Change Application (Minor Change) Town Planning Assessment

125 – 127 Sherwood Road, Toowong

MEWING
PLANNING
CONSULTANTS

Figure 10: Woodstock Road elevation, with change in heights highlighted in blue

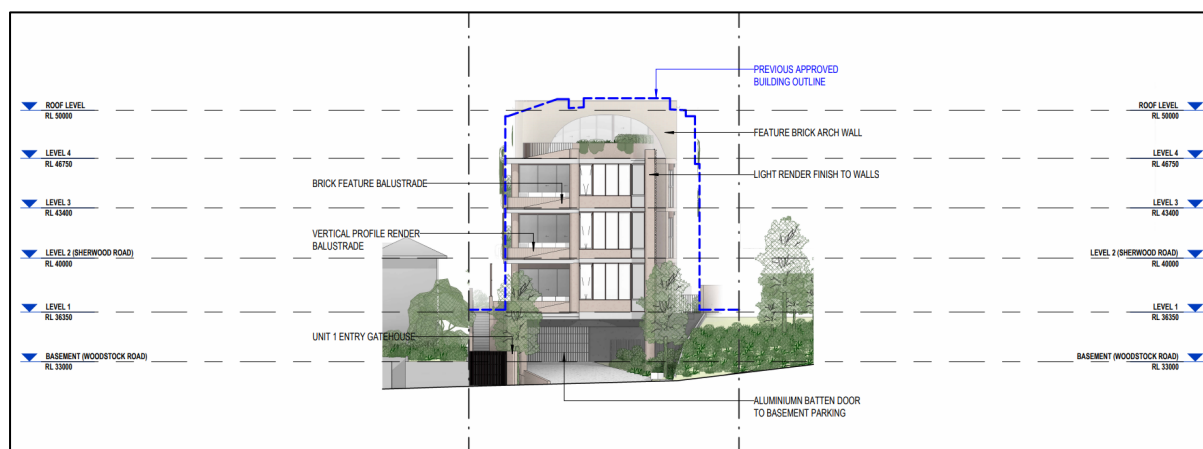
Figure 10 to 13 below illustrates the minor height difference and minimal changes in the difference in scale between the original approval and the proposed development, with the approved building outline shown in blue.

Figure 15: Proposed basement level

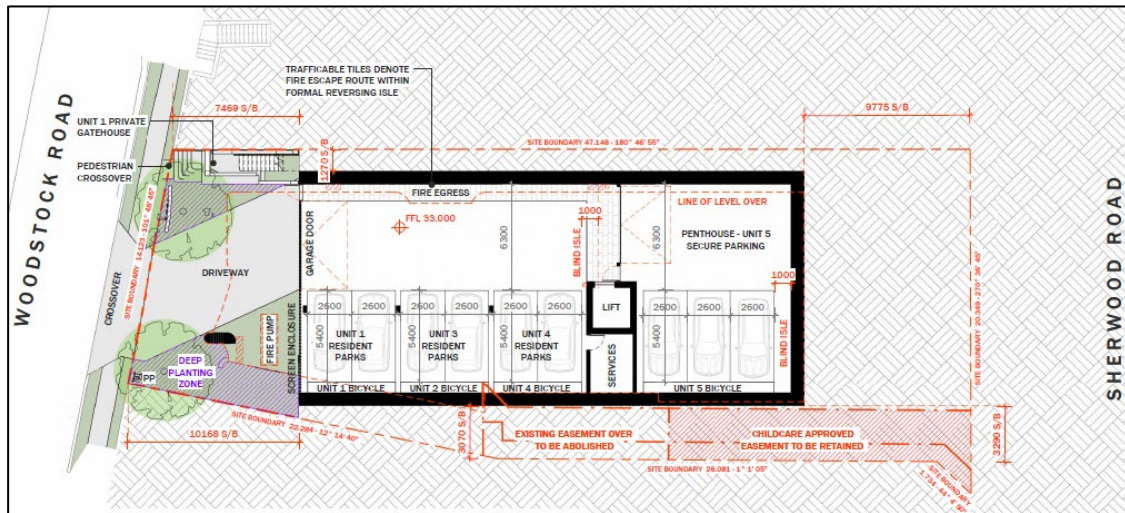
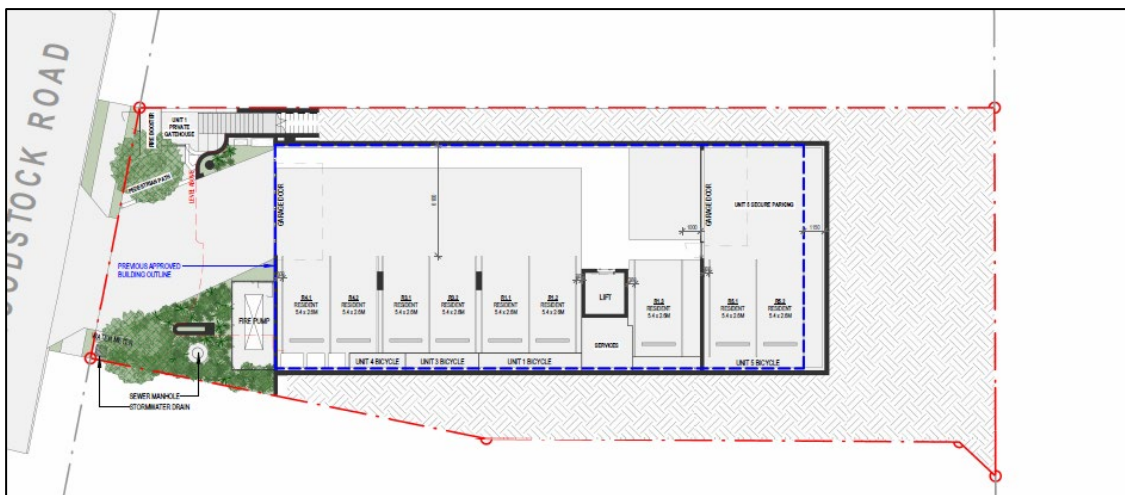
- Minor reconfiguration of the internal parking layout, including adjustments to resident parking spaces and circulation aisles, without altering the overall parking provision or functionality;
- Reorganisation of bicycle parking locations within the basement, maintaining compliance with the required bicycle parking rates;
- Refinement of building services and infrastructure, including relocation and consolidation of service elements (e.g. fire pump and associated equipment), resulting in a more efficient layout;
- Minor adjustments to the basement footprint and exclusion zones, which remain generally consistent with the approved building envelope;
- Integration of servicing and access arrangements, including clearer delineation of circulation and fire egress paths; and
- Retention of vehicle access from Woodstock Road with no change to the crossover location or access arrangement.

Figure 17: Proposed level 1 (previously labelled lower ground)

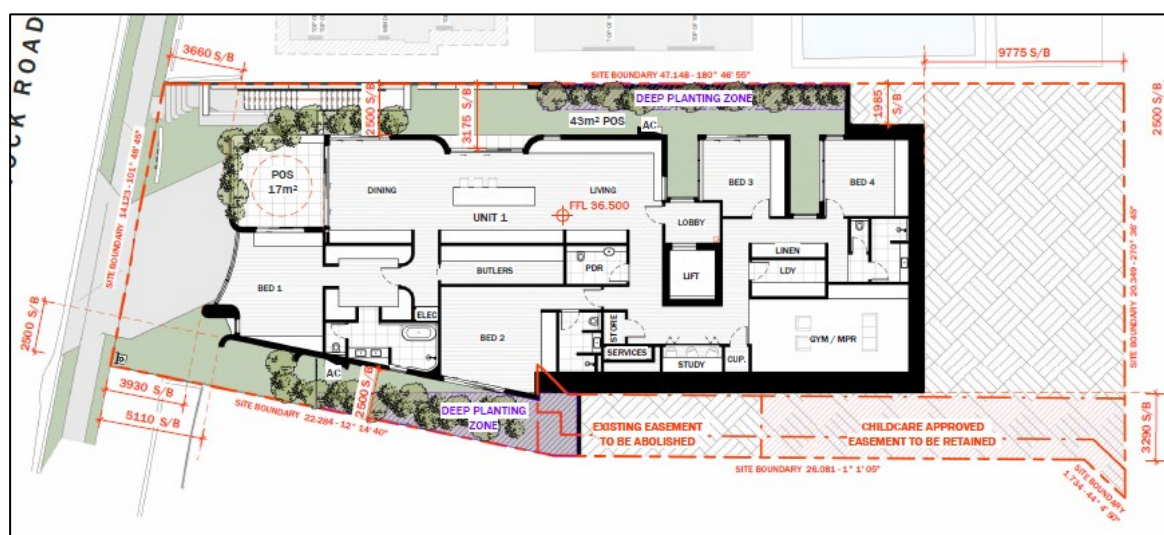
- Internal reconfiguration of Unit 1, including adjustments to the layout of living areas, bedrooms and ancillary spaces, improving internal functionality without altering the external building envelope in any material way;

- A new fire escape staircase included to the eastern side of the amended refuse bin enclosure. This fire escape staircase inclusion has been necessitated following a request from the Queensland Fire Department. The staircase is required to provide access from the Sherwood Road frontage to the lower levels of the development in the case of an emergency.

- Minor refinements to the interface with the Woodstock Road frontage, including adjustments to setbacks and landscaping zones, which remain generally consistent with the approved siting and do not introduce additional amenity impacts;

- Reconfiguration of private open space areas associated with Unit 1, including removal of balcony planters, maintaining a comparable level of amenity and usability to that approved;

Figure 19: Proposed level 2 (previously labelled ground floor)

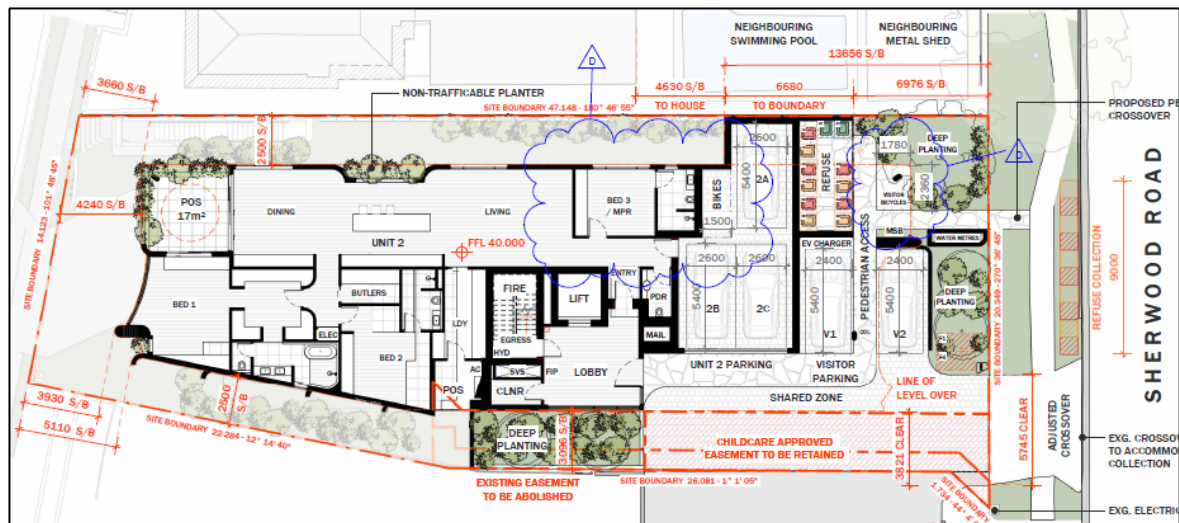
- Internal reconfiguration of Unit 2, including adjustments to the layout of living areas, bedrooms and ancillary spaces, improving internal amenity and functionality without materially altering the external building form;

- Minor refinements to the building setbacks along the Sherwood Road frontage, which remain generally consistent with the approved development envelope and continue to provide an appropriate streetscape interface;

- Queensland Fire Department required fire escape staircase leading between the ground level on Sherwood Road frontage and the lower levels of the development;

- Minor refinements to the refuse bin enclosure layout and siting, as a consequence of the new QFD staircase on the eastern side. The refined refuse bin enclosure continues to accommodate 10 bins.

- Reconfiguration of the front entry and lobby arrangement, resulting in a more legible and functional pedestrian arrival experience, without changing the primary access point;

- Minor adjustment to the crossover and driveway arrangement, including refinement of the shared zone and pedestrian interface, while maintaining access from Sherwood Road in accordance with the approved scheme;

- Reorganisation of on-site servicing elements, including utilities and refuse collection areas, to improve efficiency and integration within the ground floor layout;

- Minor adjustments to deep planting and landscaping areas along the frontage, maintaining a comparable (and improved) landscape outcome and reinforcing the presentation of the development to the street; and

Figure 21: Proposed level 3 (previously labelled level 1)

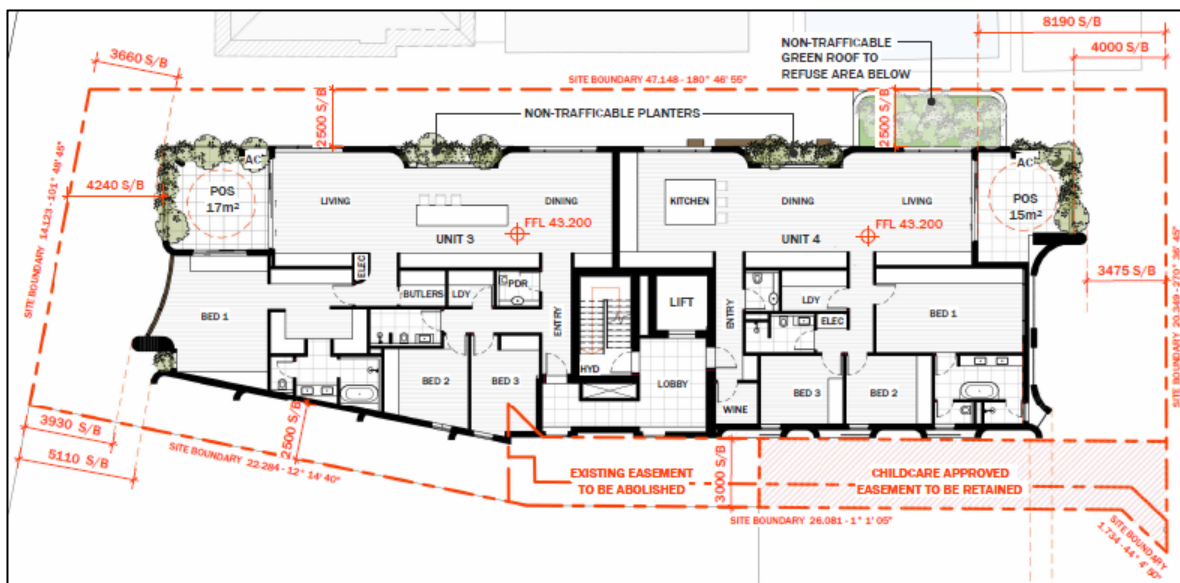
- Internal reconfiguration of Units 3 and 4, including adjustments to the layout of living areas, bedrooms and ancillary spaces, improving internal amenity and functionality without altering the external building envelope in any material way;
- Minor refinements to building setbacks, which remain generally consistent with the approved development envelope and do not result in any additional impacts in terms of building separation, overlooking or visual bulk; and
- Reconfiguration of private open space areas (balconies) and removal of balcony planters, maintaining a comparable level of amenity and usability to that approved.

Figure 23: Proposed level 4 (previously labelled level 2)

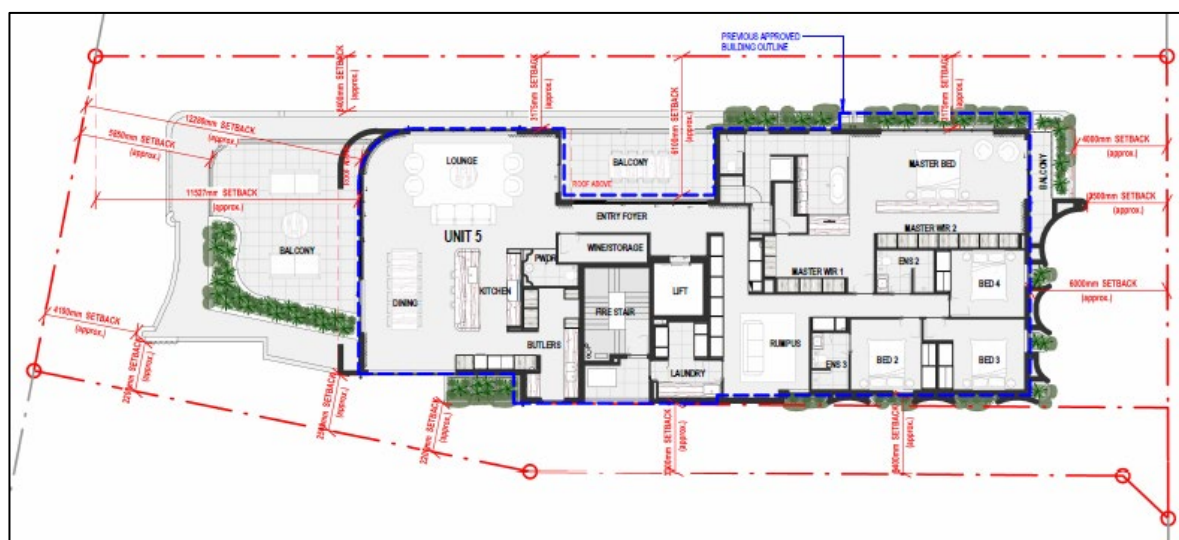
- Internal reconfiguration of Unit 5, including adjustments to the layout of living areas, bedrooms and ancillary spaces, improving internal functionality and amenity without altering the approved building envelope in any material way;
- Minor refinements to setbacks and built form articulation at the upper level, which remain generally consistent with the approved siting and do not result in any additional visual bulk or dominance when viewed from the surrounding streets;

- Reconfiguration of private open space areas (balconies and terrace areas), including removal of some balcony planters to Unit 3, maintaining a high level of amenity consistent with the approved design;
- Revised built to side boundary containerised planter to respond to the new QFD required staircase;
- Inclusion of new container planters to the Sherwood Road frontage
- Minor adjustments to planter locations and landscaping elements at the upper level, which continue to provide softening of the built form and contribute to the overall landscape character of the development; and
- Retention of the approved upper-level setback and articulation, ensuring that the development continues to present an appropriate transition in scale to adjoining properties, particularly to the eastern residential interface.

Figure 24: Comparison of Northern Elevation (Woodstock Road) (Approved at top, proposed at bottom)

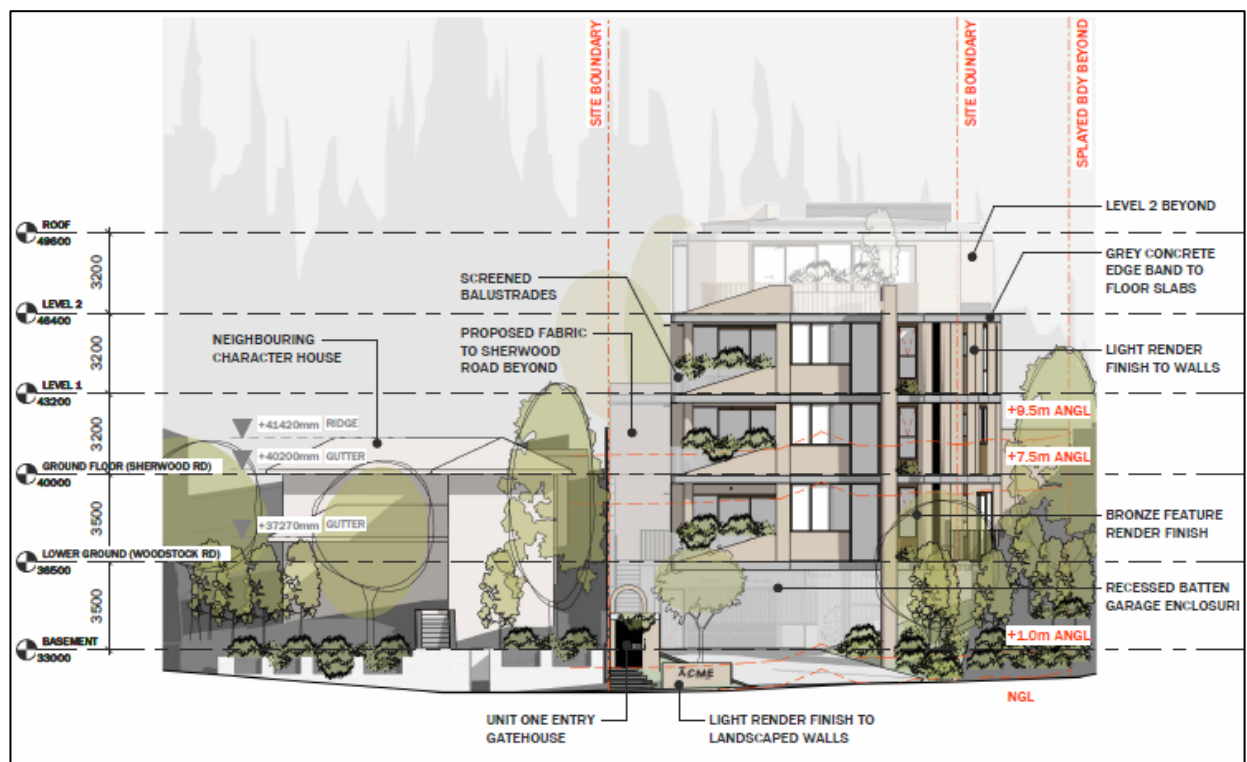
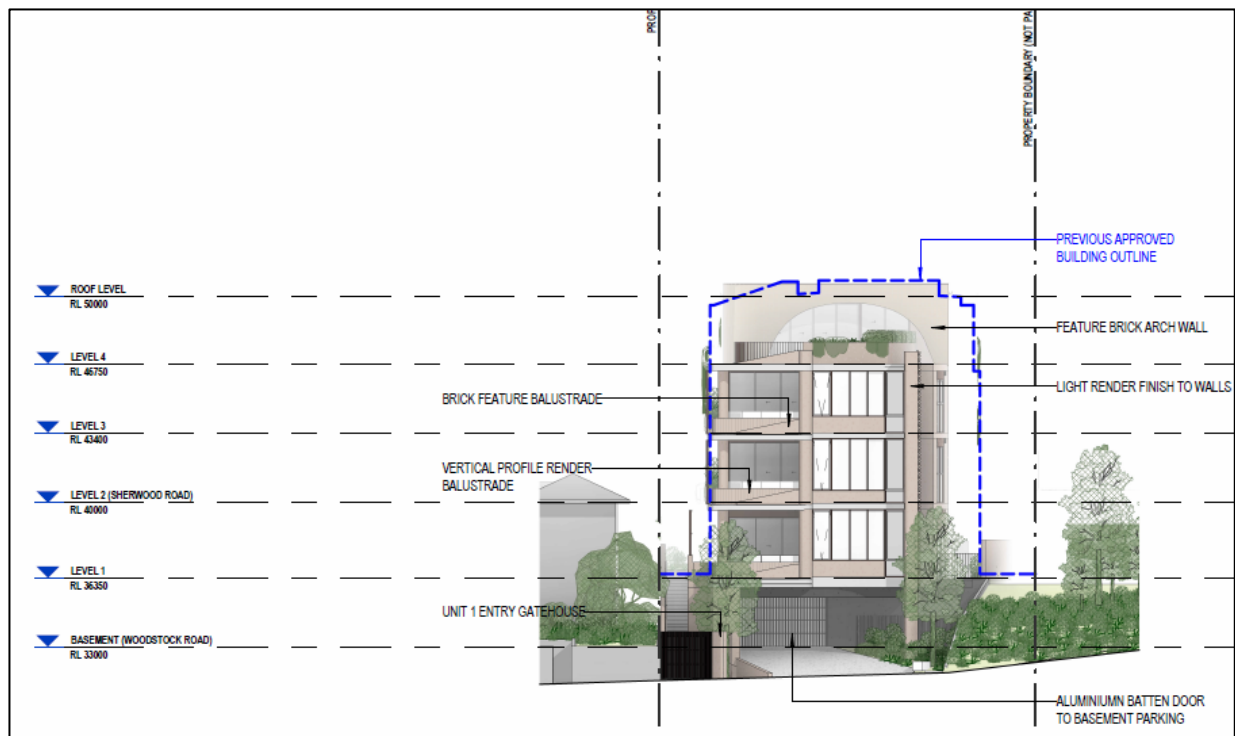
- The materiality of the feature “angular” balcony balustrading has been revised to a brick and vertical render profile;
- Entry gatehouse design revised;
- Services box shown where required on the eastern side;
- Rationalisation of balcony planters, to attend to maintenance matters and to provide improved occupancy of the balcony spaces; and
- Glazing profile updated to align with internal layout revisions.

Figure 25: Comparison of the Sherwood Road facade, with the approved on the top and the proposed on the bottom

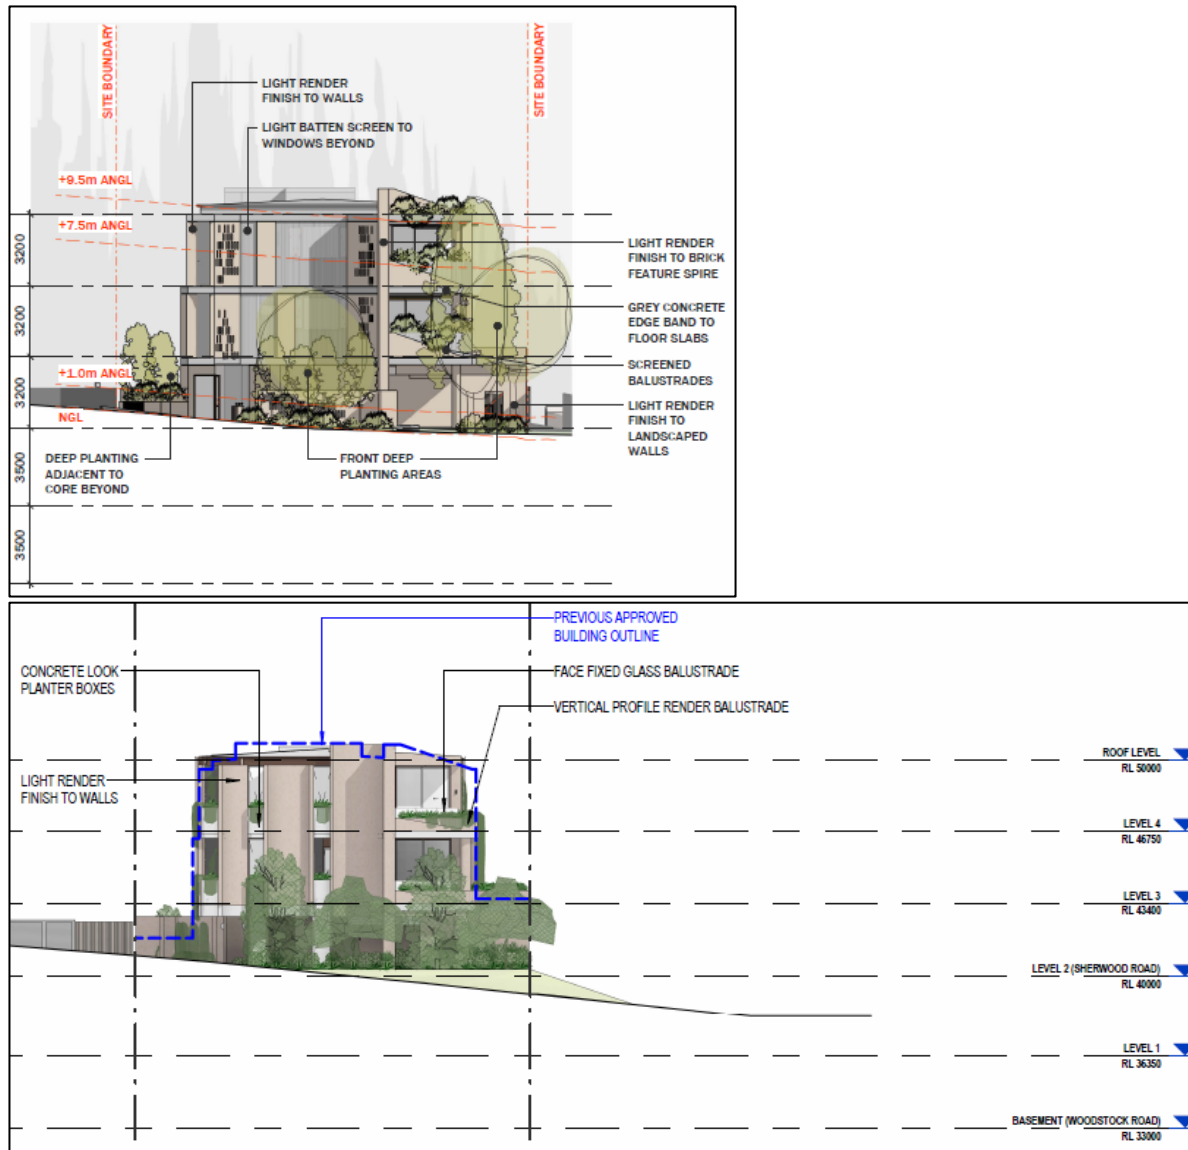
- Refinement of balcony balustrading, including adjustments to materiality and transparency (comprising a combination of rendered, vertical profile and glazed elements); and
- Addition of concrete look planter boxes and minor changes to the inclusion of landscaping throughout the built form.

Figure 27: Comparison of the western façade, with the approved on the top and the proposed on the bottom

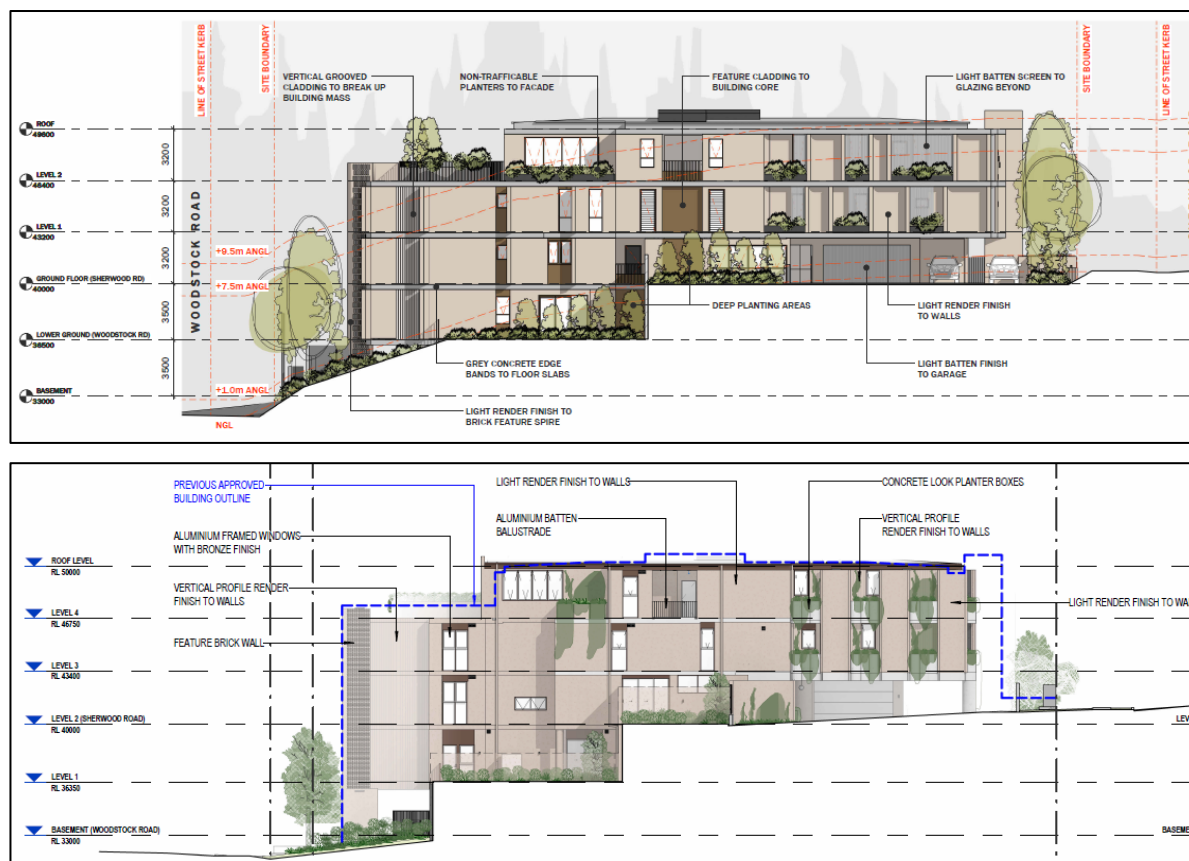
- Minimal changes to the building envelope, and overall articulation of the western elevation are proposed, with increased setbacks at Levels 3 and 4 to reduce the perceived bulk and scale of the building;
- Minor update to the built to boundary wall on the Sherwood Road frontage to accommodate the new QFD required fire escape staircase.
- Minor updates to façade detailing and material finishes, which are consistent with the approved architectural language and do not alter the visual presentation of the building;
- Integration and clearer depiction of planter boxes and containerised landscaping elements, contributing to softening of the built form;
- Minor adjustments to glazing and façade elements to align with internal layout refinements, without increasing overlooking or visual bulk; and

- Retention of the approved level of articulation and screening, ensuring the elevation continues to present an appropriate interface to adjoining properties.
